Mayberry Filing No. 3
Traffic Technical Memorandum
(LSC #S224210)
May 19, 2022

Please add PCD
File No. SF2219

Traffic Technical Memorandum

Figure 1

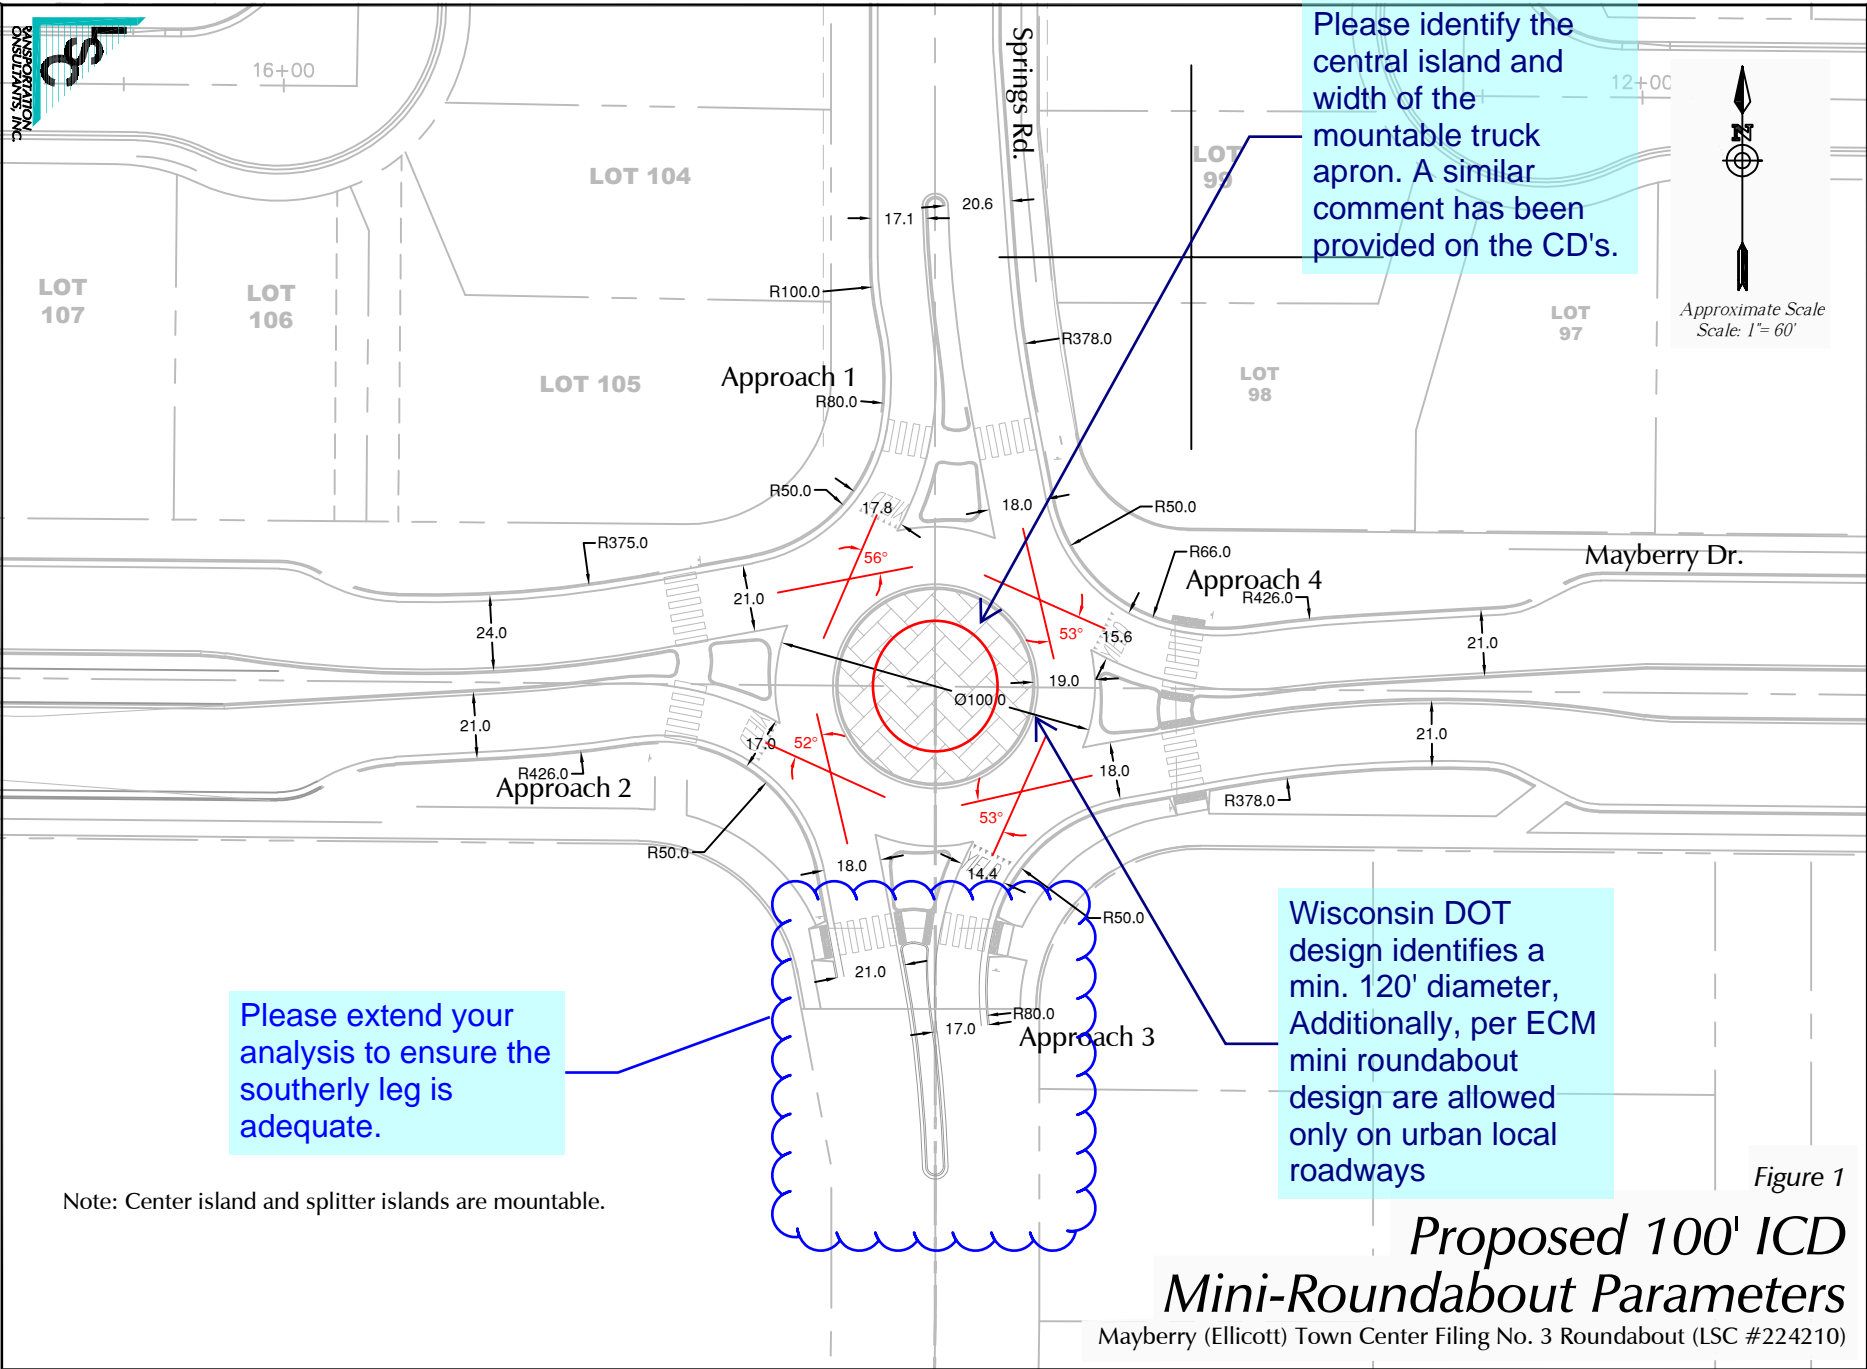
Please identify the central island and width of the mountable truck apron. A similar comment has been provided on the CD's.

Provide turning paths for EPC plow dimensions (assuming plow down) also. See attachments

Figure 2

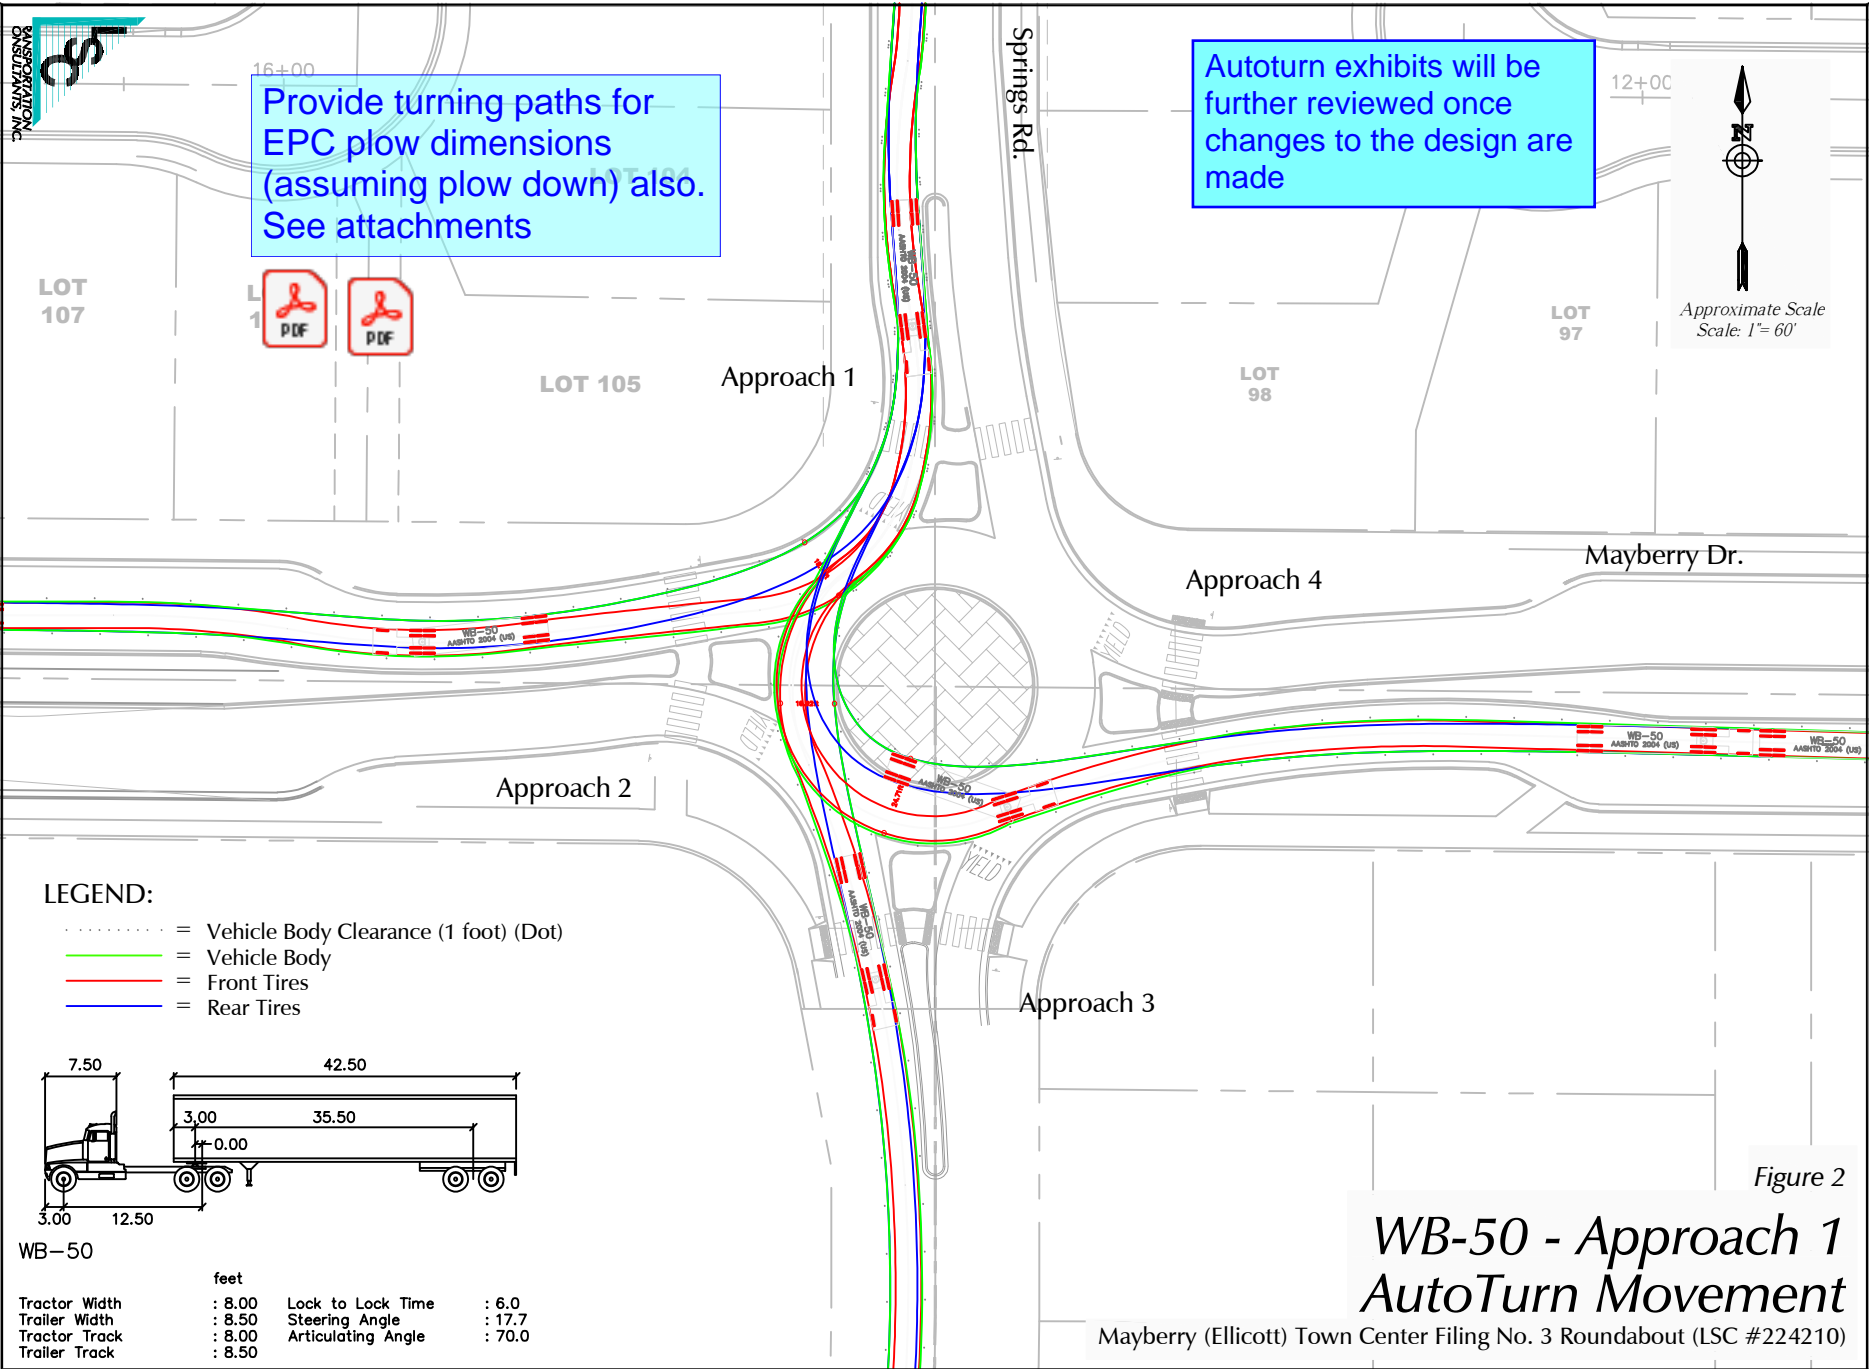
Autoturn exhibits will be further reviewed once changes to the design are made

Figure 13

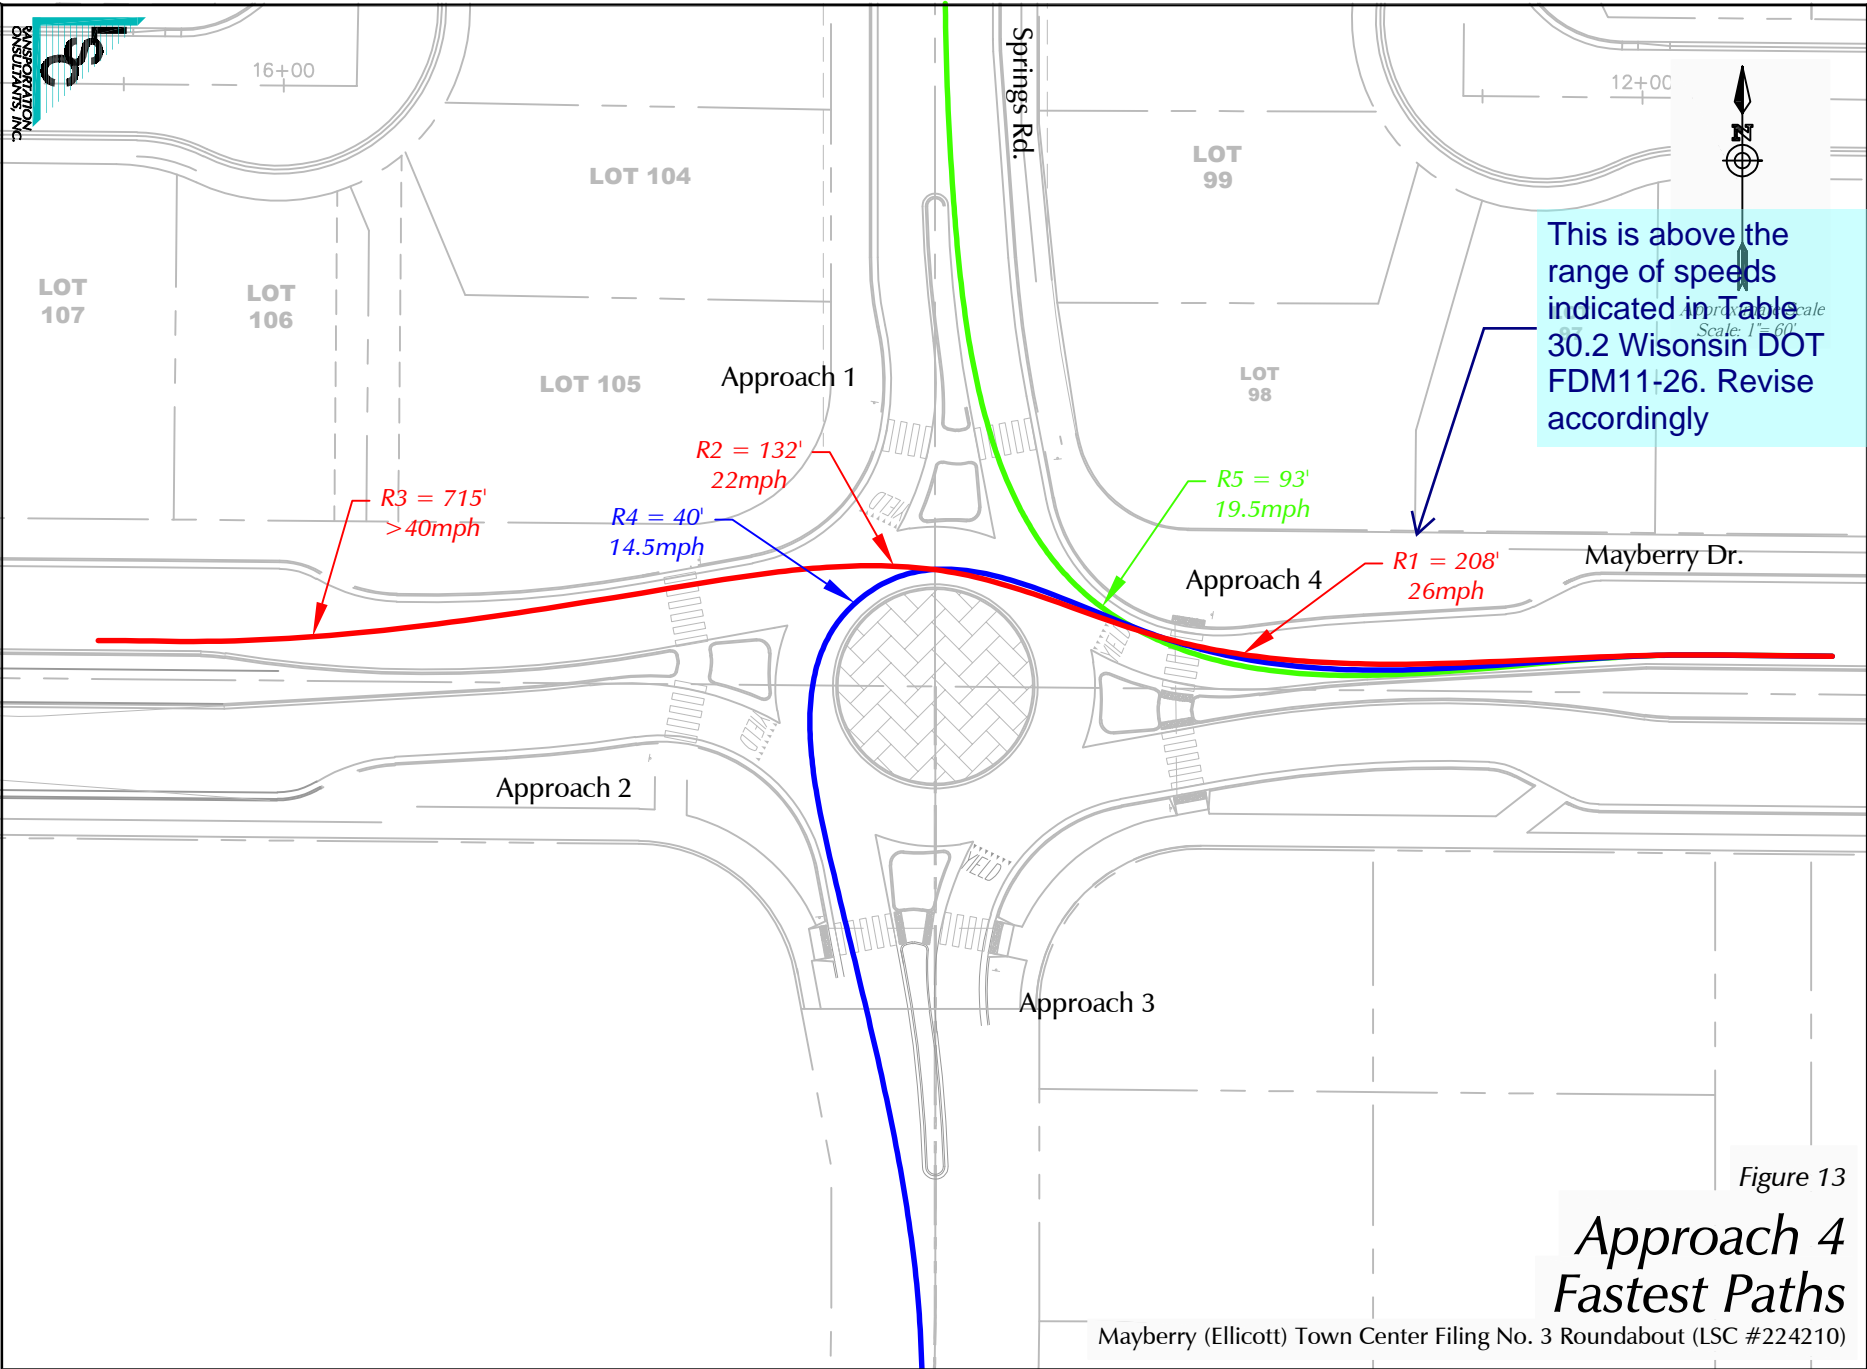
This is above the range of speeds indicated in Table 30.2 Wisconsin DOT FDM11-26. Revise accordingly
